Re: Request for Concept Review

I am writing to request the opportunity to present a revised concept plan to the Planning Board in August for my property at 985 Aquidneck Ave, owned by Seascape Holdings LLC. I am the principal of Seascape Holdings LLC as well as Trademark Builders LLC that occupies a portion of the property that this improvement is intended for. As you know, a proposal was presented to the board for this property at the June meeting. At that meeting, concerns were expressed regarding the building design and excessive waiver requests. As you will see in the proposed revisions, we have gone to great lengths to reconfigure the building location to significantly reduce the setback variance request to the northerly lot line and provide a revised building design that provides architecture cohesive with the existing building on site. This revision also eliminates many of the waiver requests associated with the previous design, and significantly improves the elevations visible from the public right of way while reducing the visual massing by presenting a smaller gable end elevation to the streetscape.

My response to a few questions referanceing 985 Aquidneck Ave.

① SITE PLAN - PROPOSED
1" = 20'-0"

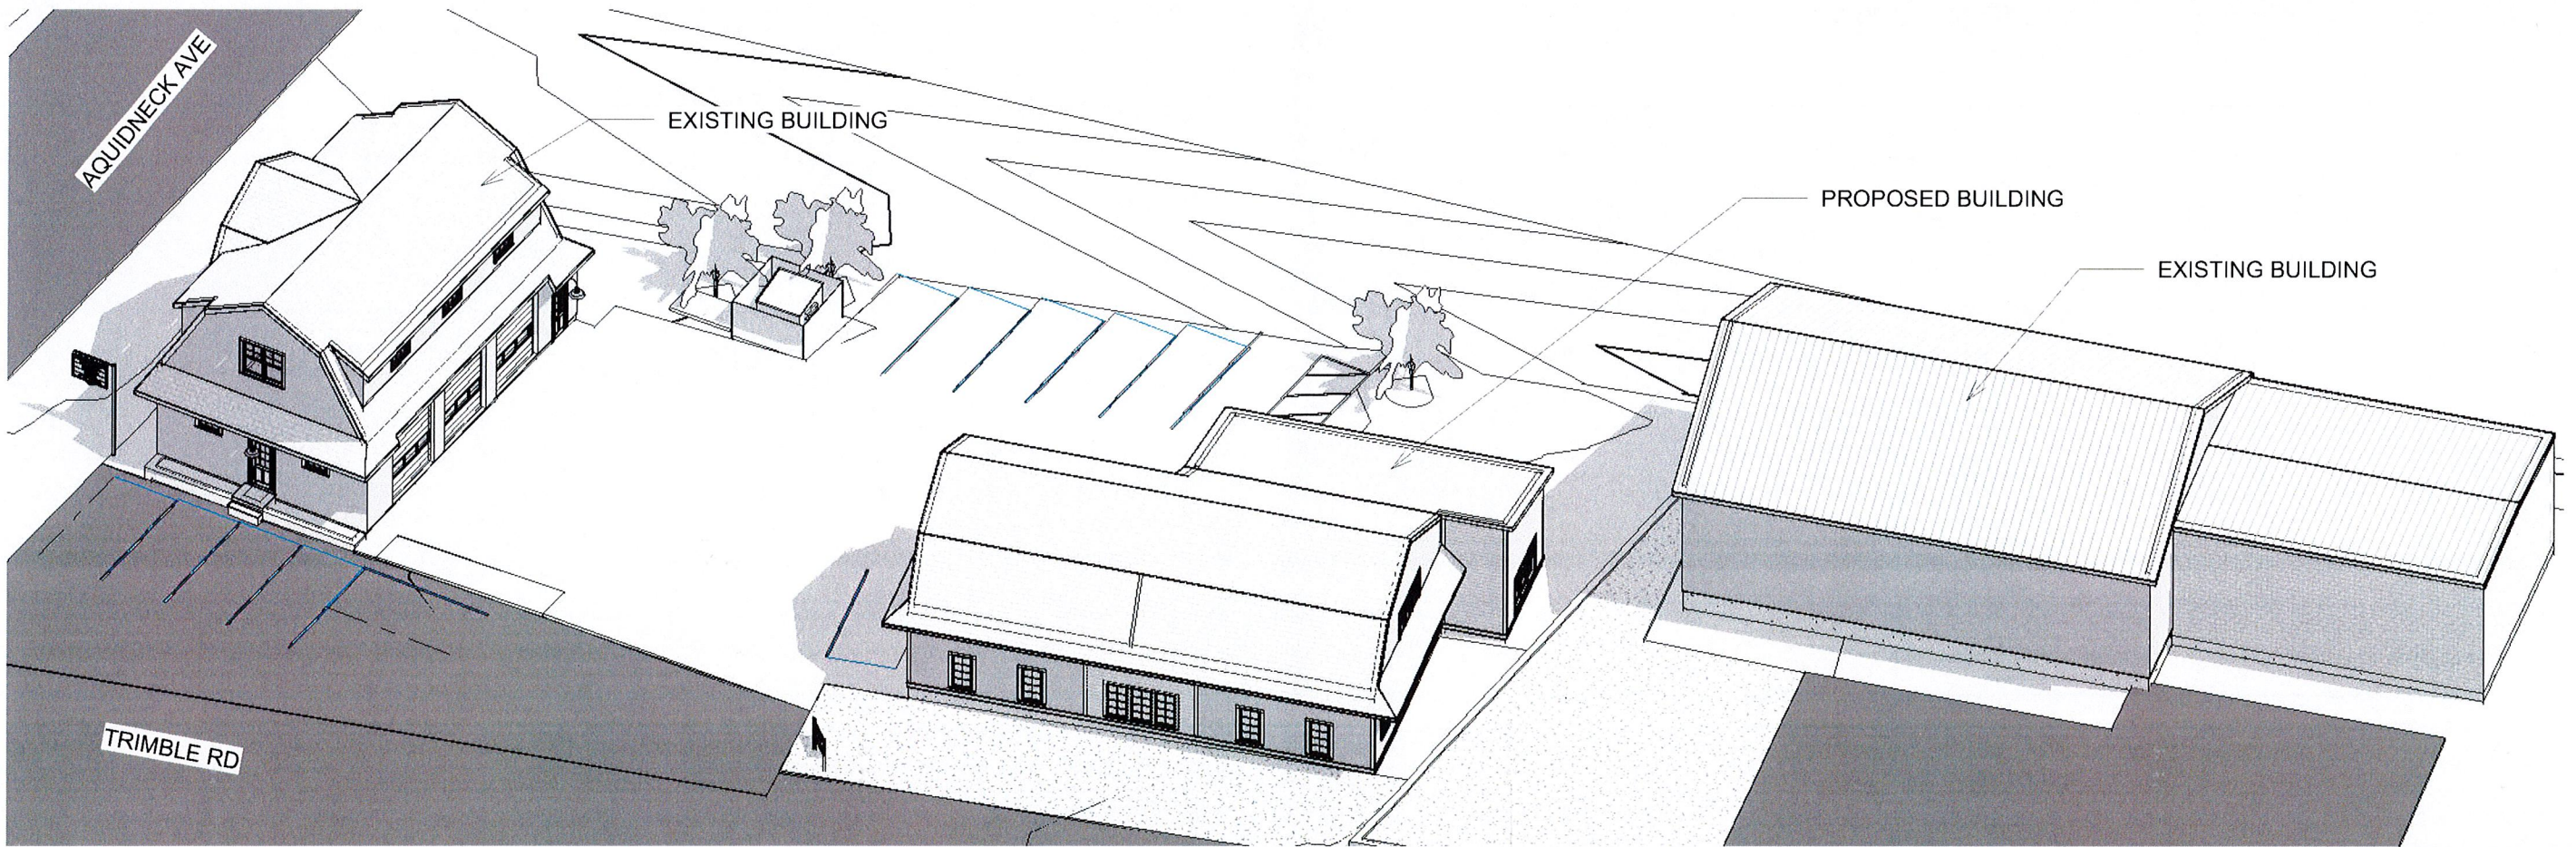
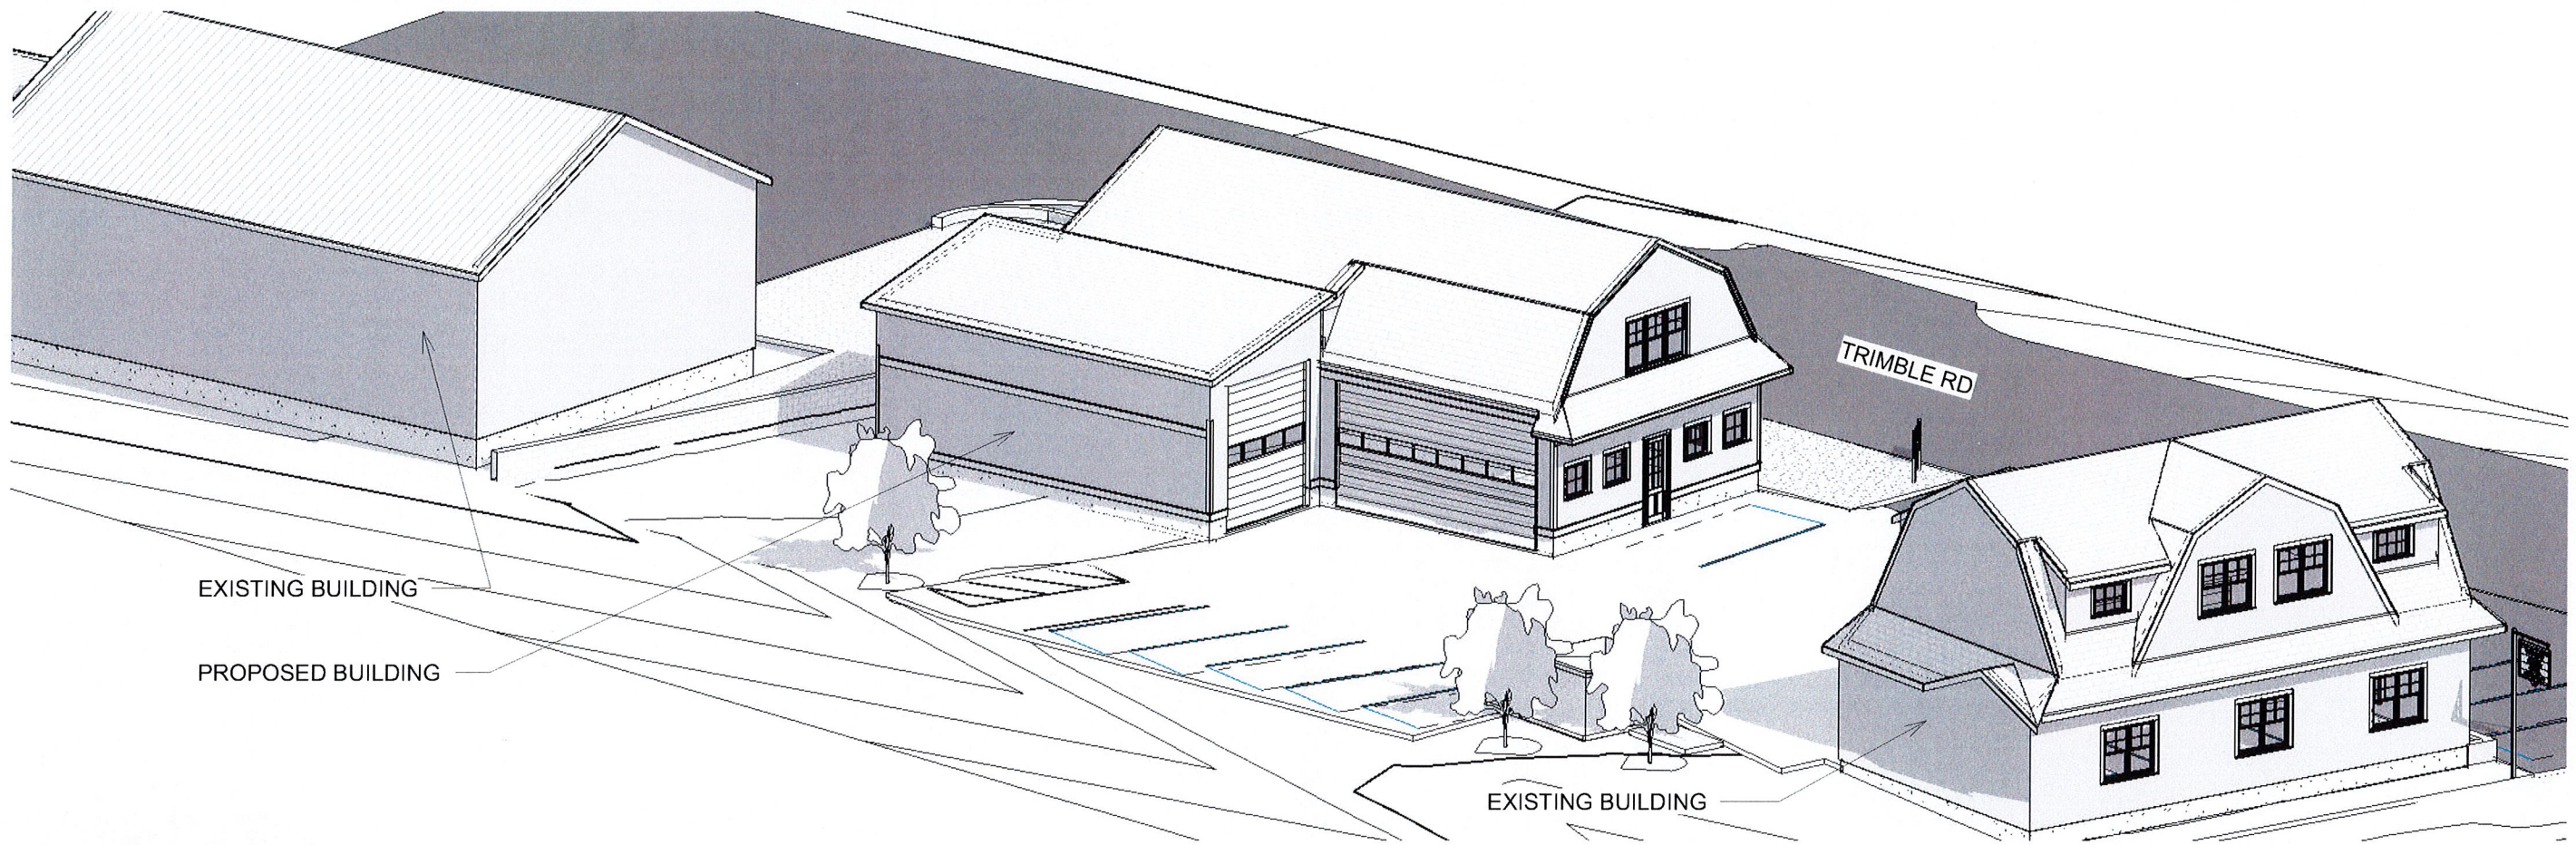
- 4) Existing parking- You and I discussed that I should have the right to count the existing parking adjacent to Trimble Road in my calculations. As you'll see in the attached plan, we have laid out 5 spaces appropriately to ensure none encroach on the right of way. If you could weigh in on the validity of my proposal in this regard that would be helpful.
- 5)

Those existing parking spaces were good and accepted since that property existed.
